WORLD WAR II MEMORIAL: FDR D-DAY PRAYER DESIGN DEVELOPMENT

MAY 20, 2021

PRESENTATION TO THE
COMMISSION OF FINE ARTS

Center Medallion Option 1 Medal of Freedom

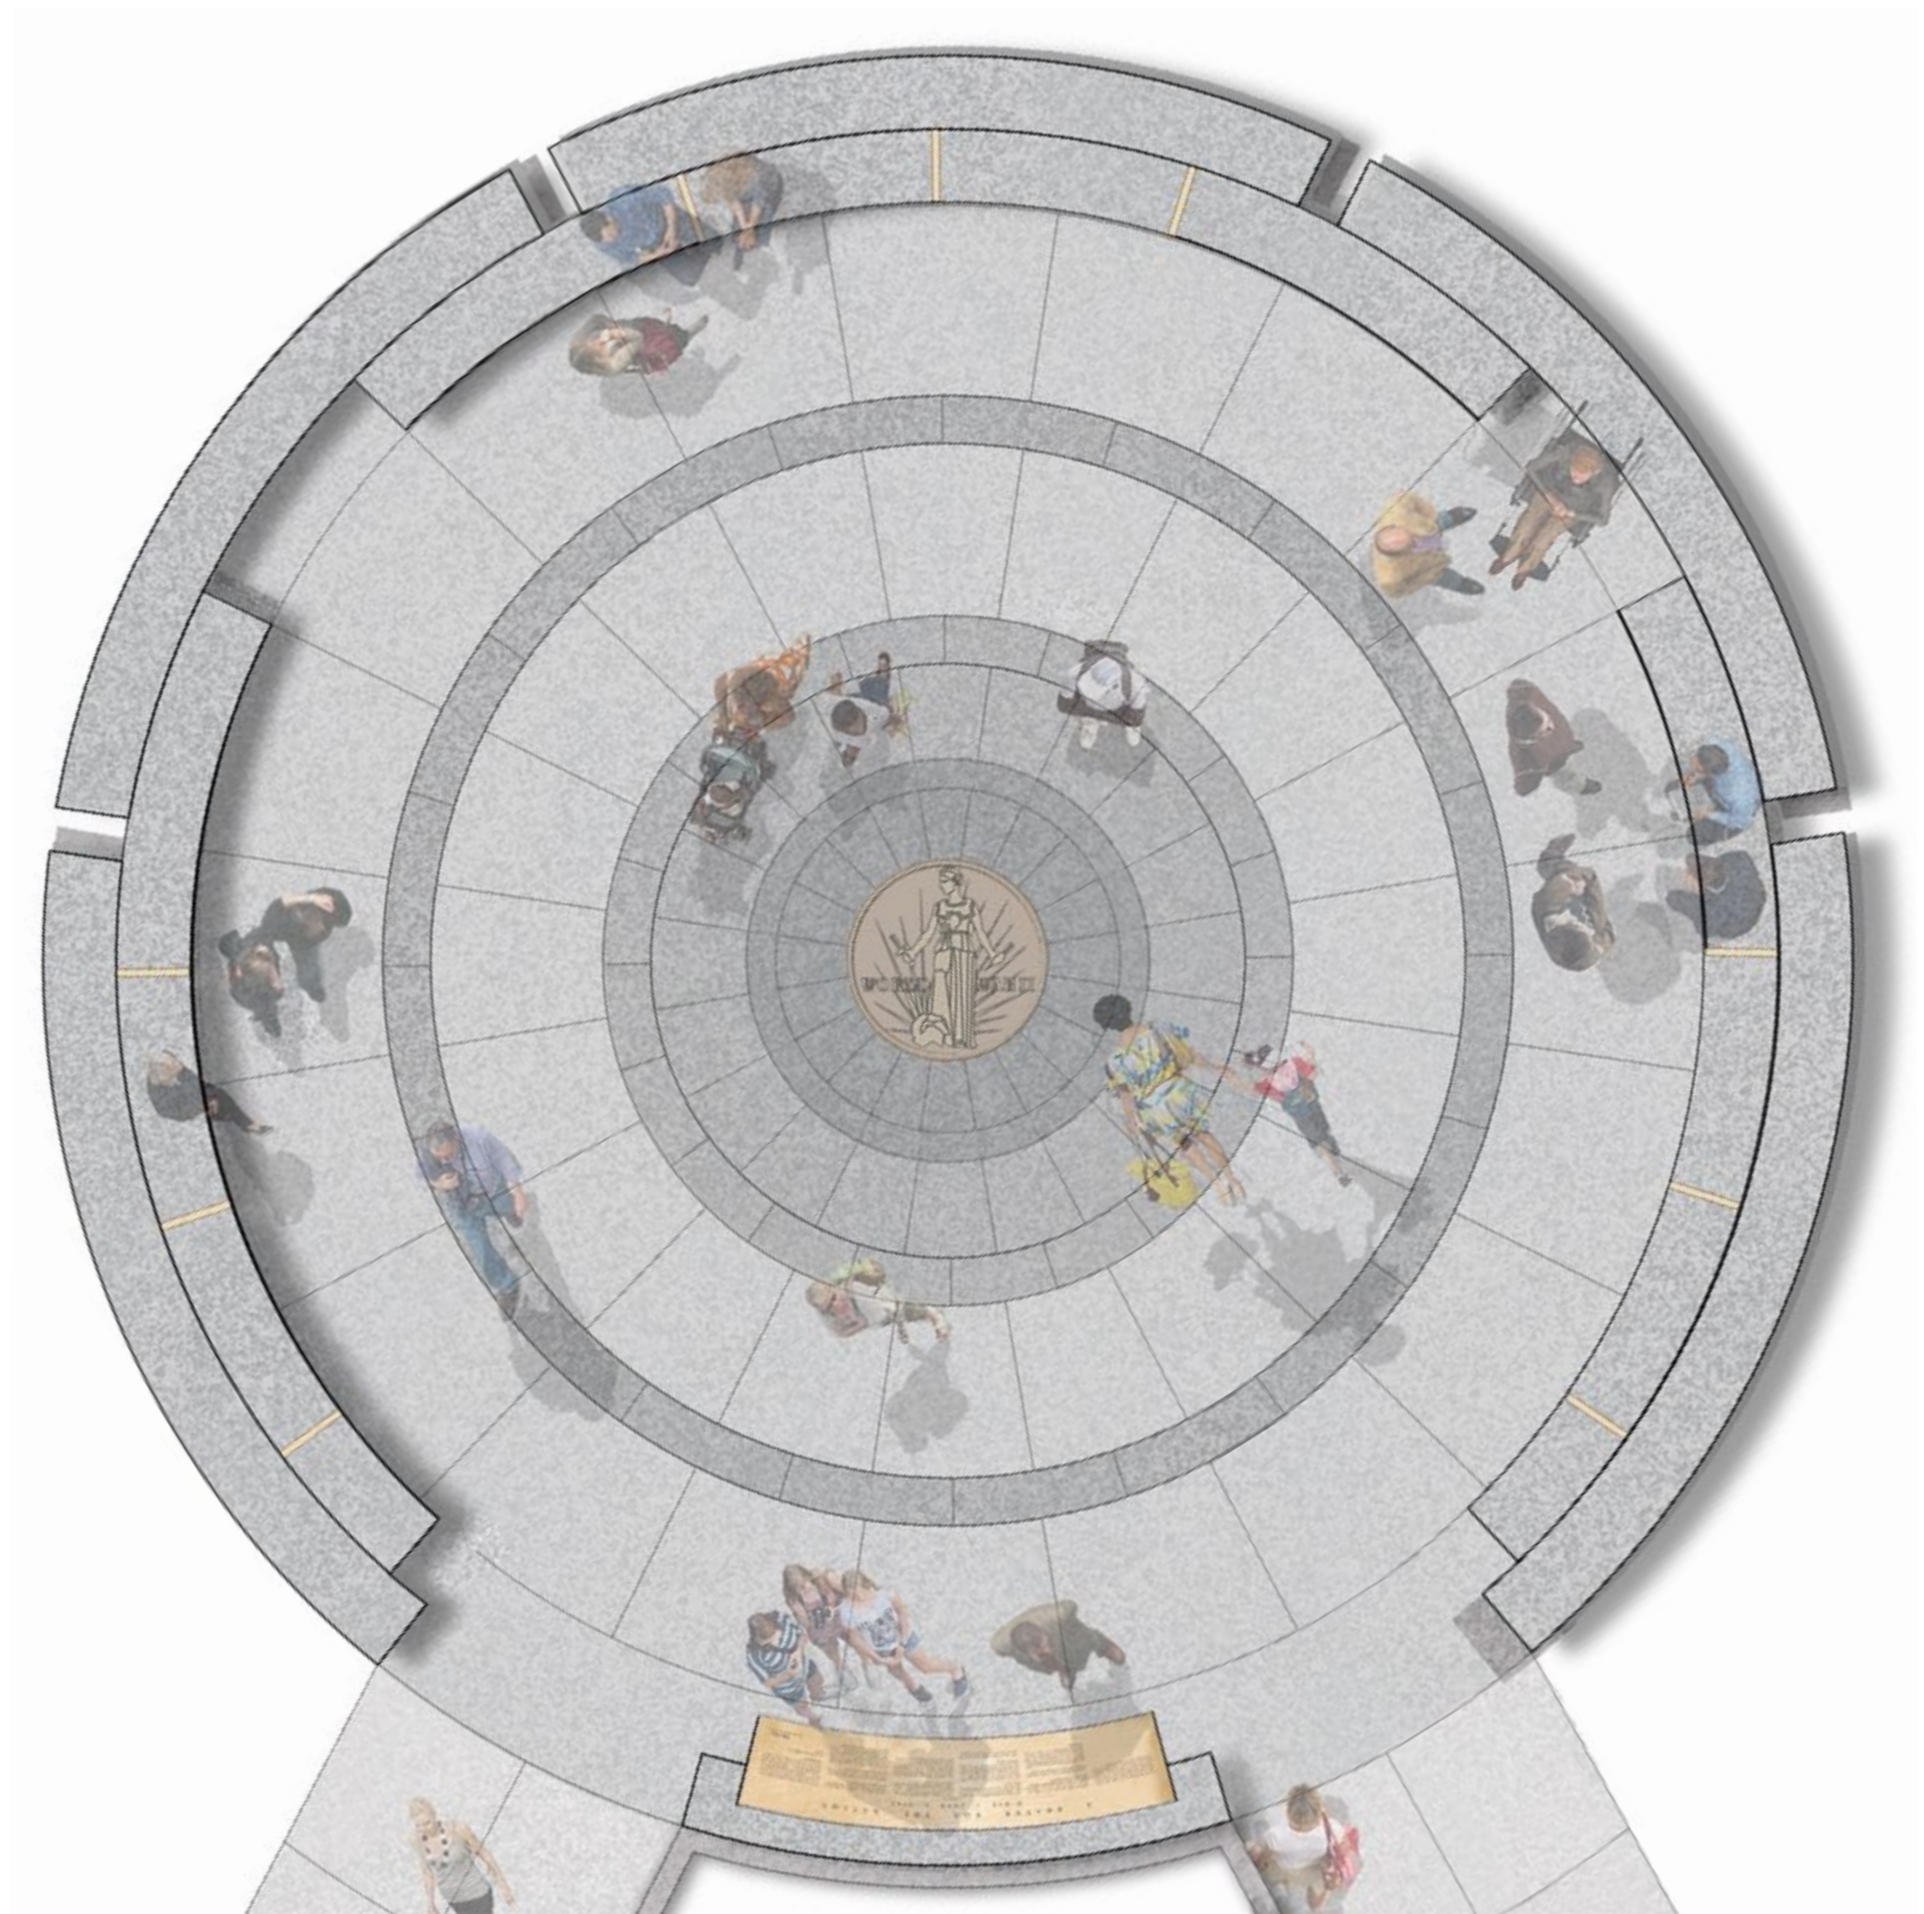
In their discussion, the Commission members agreed in their support for the addition of a large, circular motif within the pavement at the center of the circle. However, they raised concerns about the proposed reinterpretation of the World War II Victory Medal bas-relief bronze medallions located within the Atlantic and Pacific arches of the memorial, particularly at an enlarged scale and as bronze linework inlaid into a background of stone. They suggested considering a cast bronze bas-relief medallion no larger than those in the memorial, or developing a different design that employs abstracted nautical imagery evocative of the D-Day setting, or using a non-directional motif such as a laurel wreath consistent with the non-axial configuration of the Circle of Remembrance. They cautioned that any feature proposed for the center of the pavement should not compete with the prayer plaque itself, which should convey the primary honorific meaning of the circle.

- Bronze Medal of Freedom medallion
- Size to match the Atlantic and Pacific Arches of WWII Memorial (*Diameter 6'-0"*)
